ISO SC12/WG1 TF4 Status

F. RENAUDIN
18th September 2013

Presentation of TF4

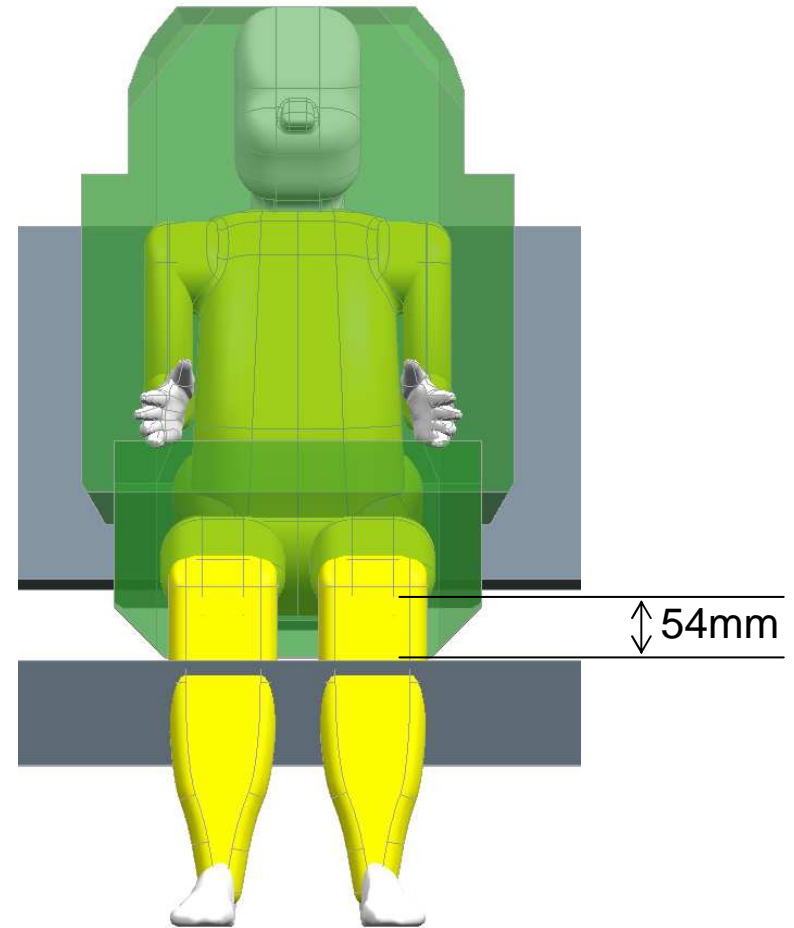
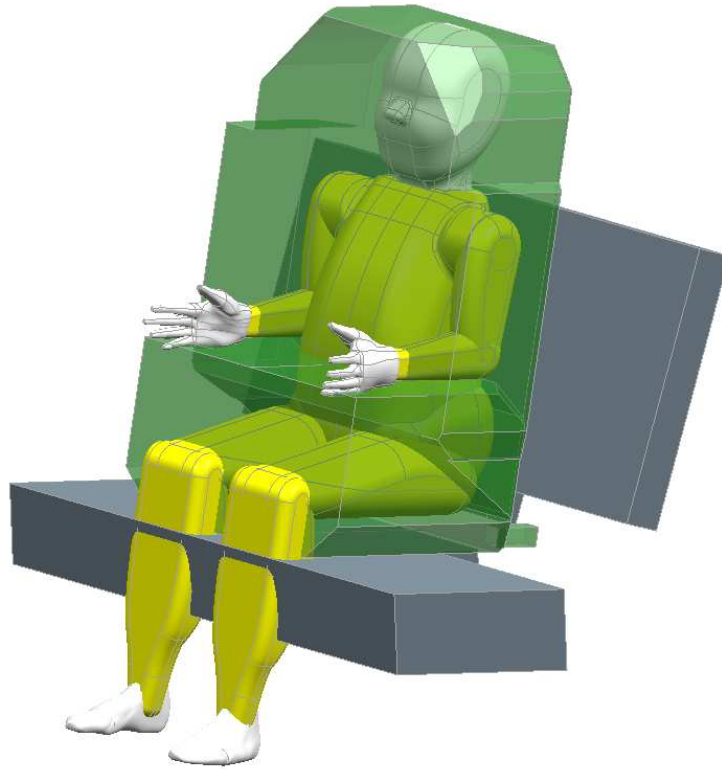
135 P95 into CRF

Not enough cushion thickness for 135 P95

TÜB CRF modifications : N1007

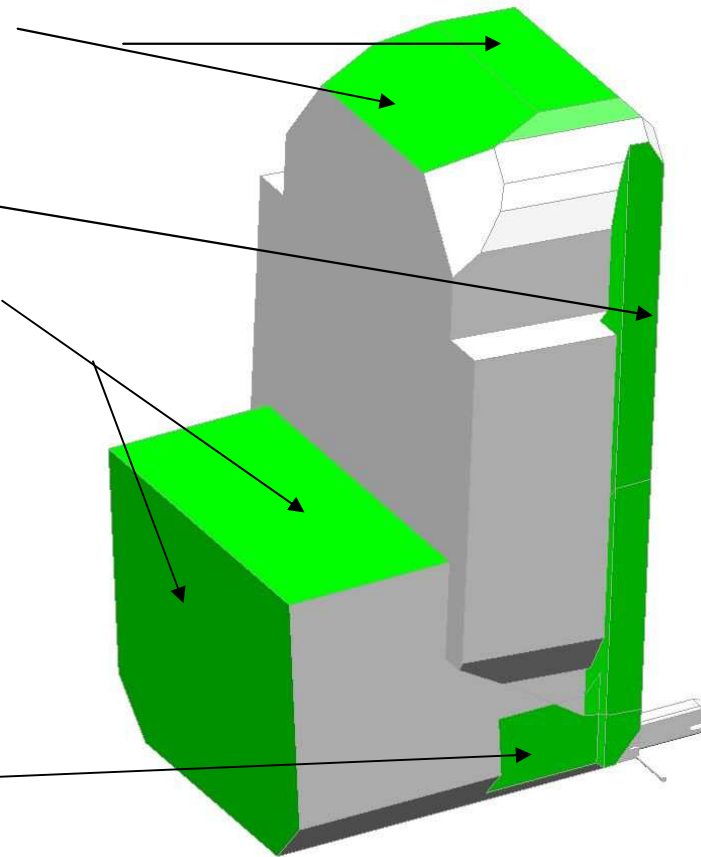
- CRF modification proposed : green areas

Top areas : +2 cm + a cut for 800 mm

Rear shape of ISO CRF
95°-110° angle for the back side

Increase of Cushion height and length

Introduction of lateral recess

Feedbacks from N1007

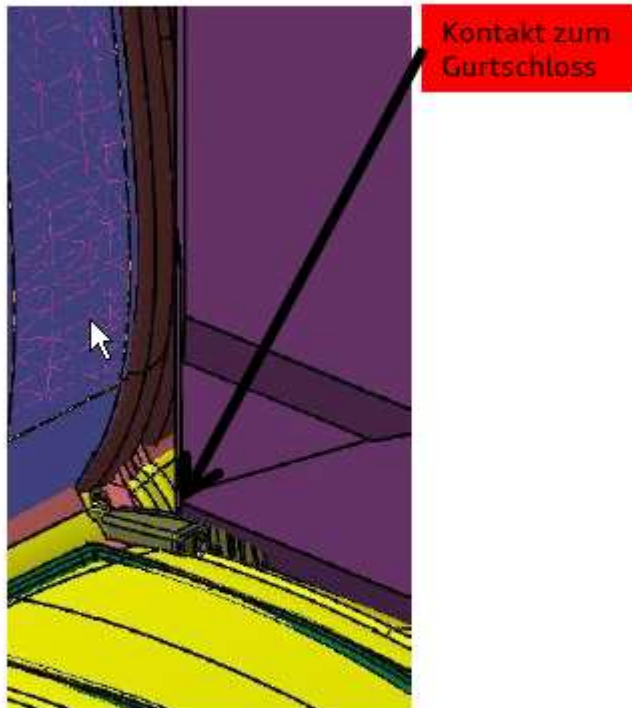
- Need to enlarge backrest angle from 90 to 110°

Feedbacks from N1007

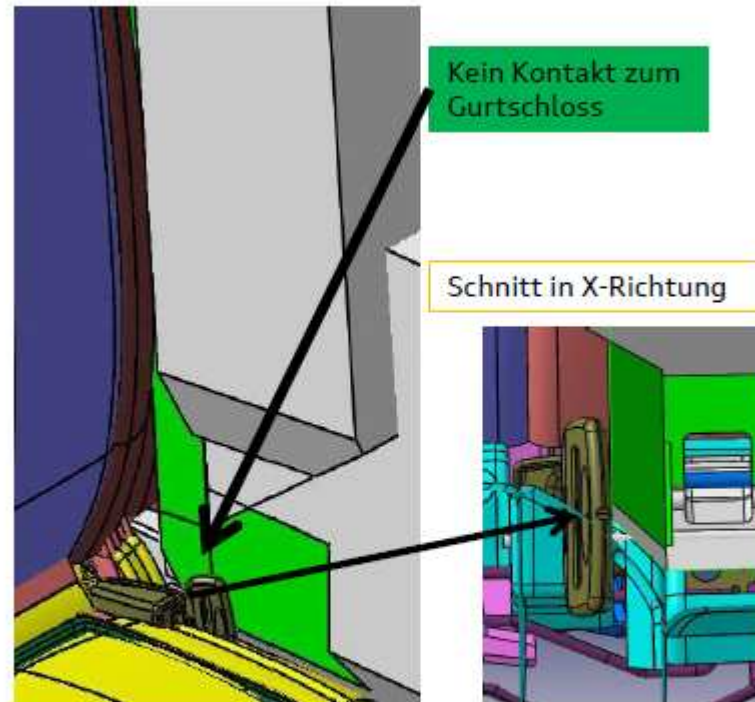
- Buckle accessibility N1015

► **CRF 135:**

► **Vorschlag Dorel:**

Feedbacks from N1007

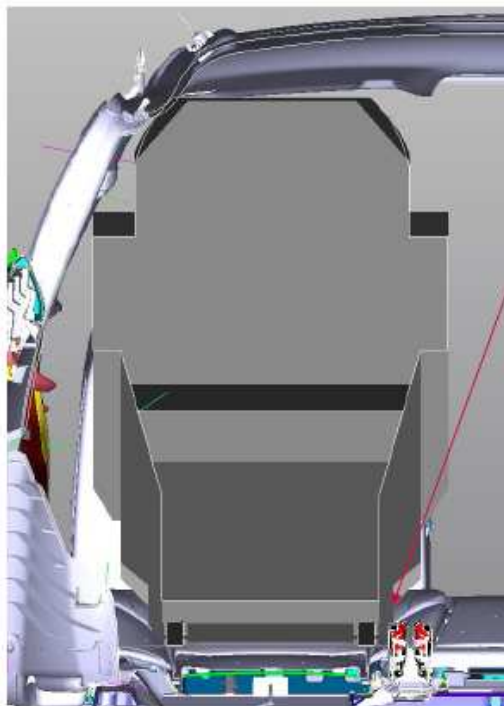
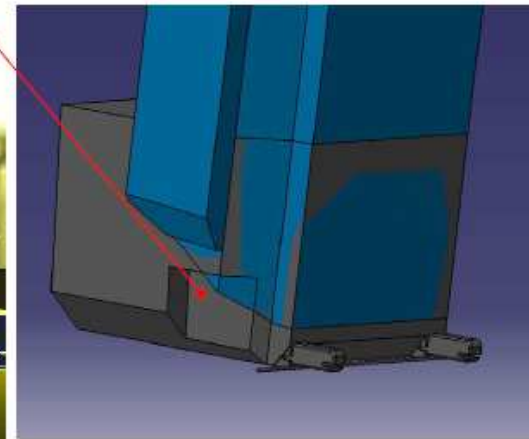
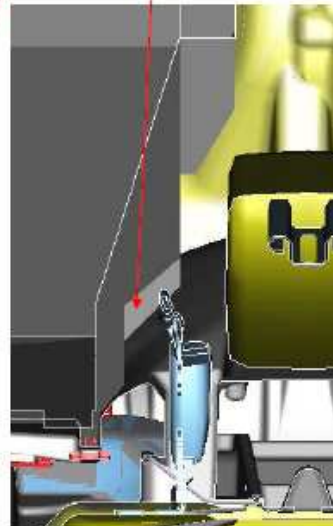
- Buckle accessibility N1023

Close up view buckles, outboard seats

Sufficient cut-out for buckles

Feedbacks from N1007

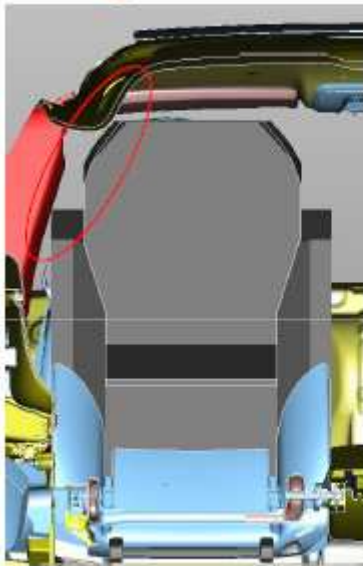
- Buckle accessibility Renault analysis no ISO N number
 - Interference with a non rigid buckle

Feedbacks from N1007

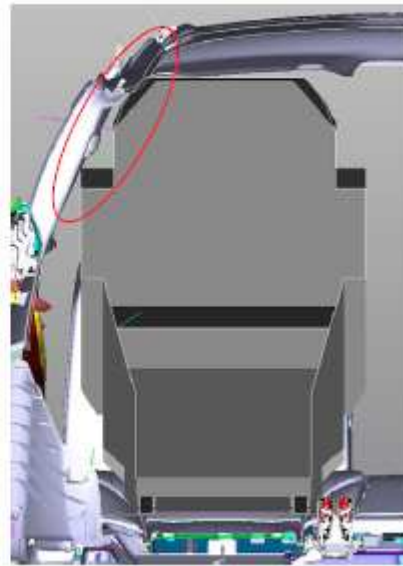
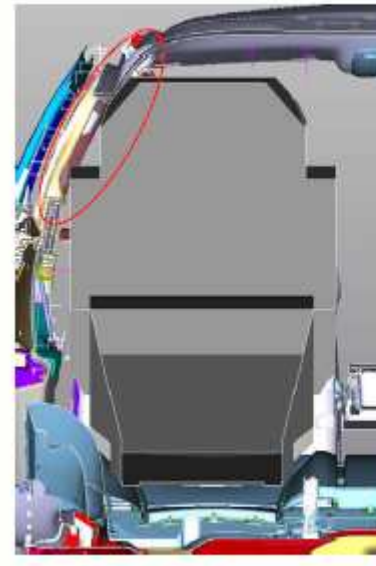
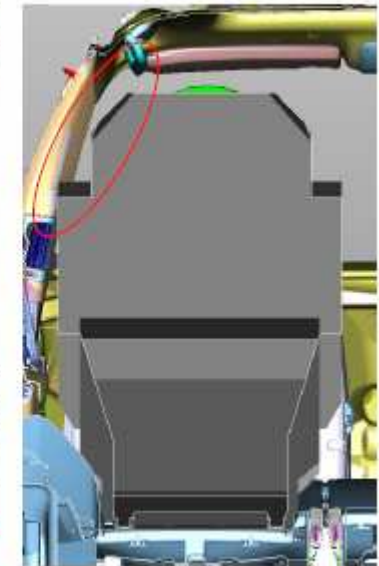
- Remarks N1023

Note: Clearance and smooth surface on CRF needed for IC deployment

Feedbacks from N1007

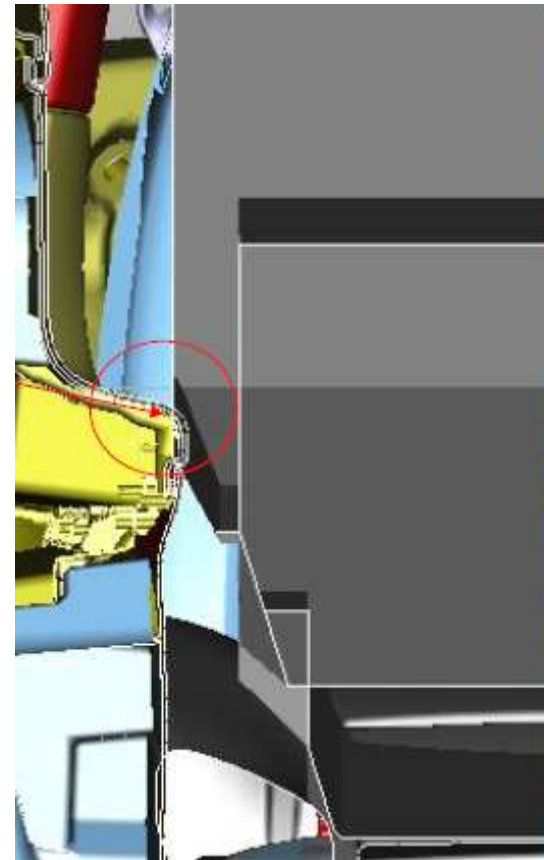
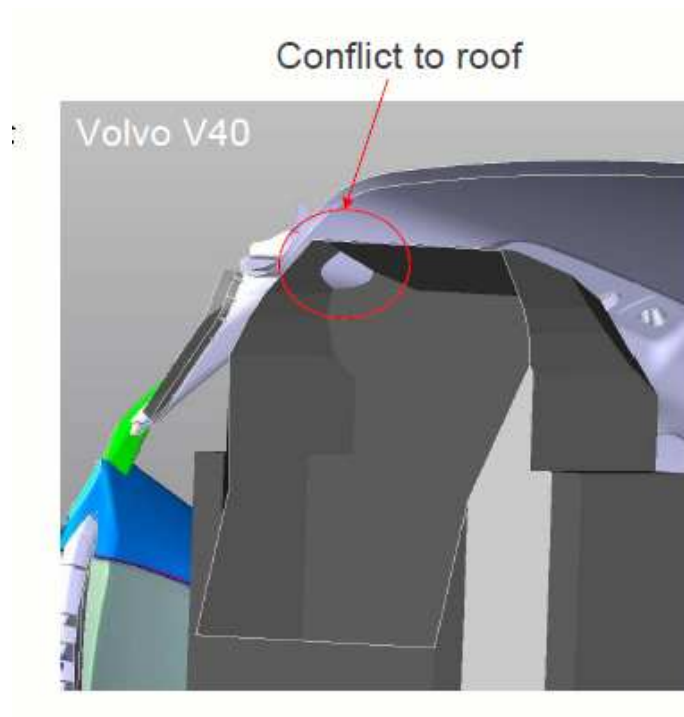
- Other interferences N1023

Transition height

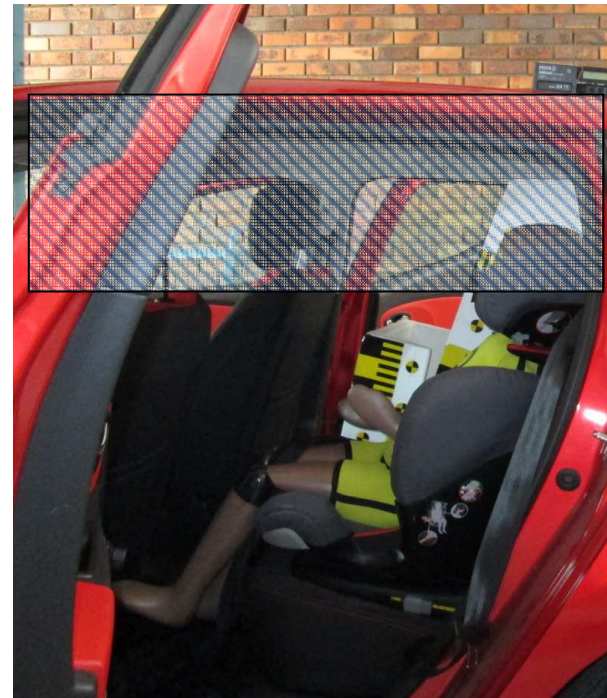
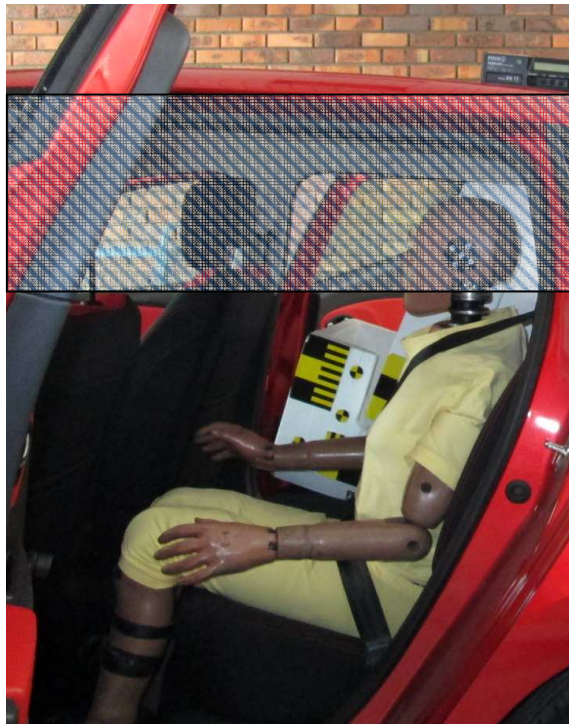
- Proposal

Assumptions : Cars protect the 5th percentile female

A CRS must protect a child head up to a position of [750 mm] in height compared to Cr point.

Consequences : Possibility to Reduce the CRF in height
